# SERVICE No. 203 BULLETIN

Piper Aircraft Corporation

SUBJECT: Modification of Cabin Heat Box Plate

MODELS AFFECTED: PA-22-108 Colt Aircraft - Serials 22-8000 to 22-8440 inclusive and 22-8443

SERVICE BULLETIN N<sup>o</sup> 203

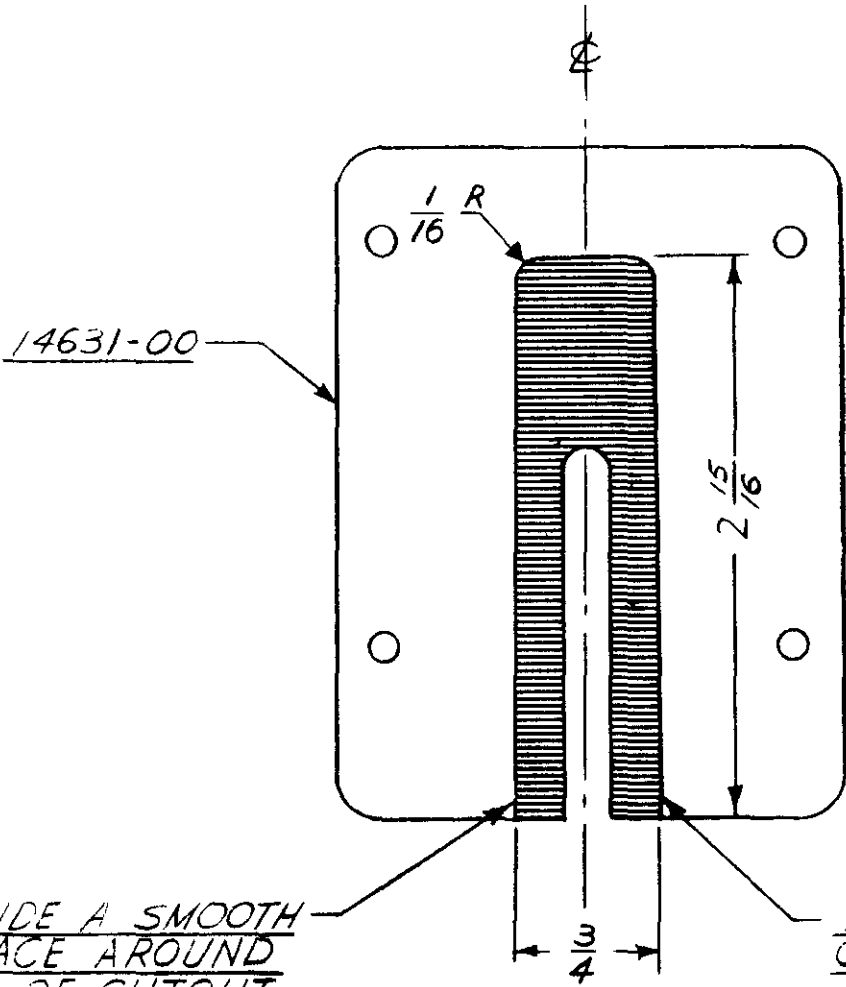
The cabin heat box plate part number 14631, interferes with the movement of the safety belt attaching link. This restriction of movement prevents the safety belt loop from contacting the entire bearing surface of the link when the safety belt is in use.

It is requested that the cabin heat box plate be modified in accordance with the sketch of the reverse side on this bulletin.

PROVIDE A SMOOTH SURFACE AROUND EDGE OF CUTOUT TO AVOID ABRASION OF SEAT BELT.

TRIM MATERIAL CUT OF AREA INDICATED
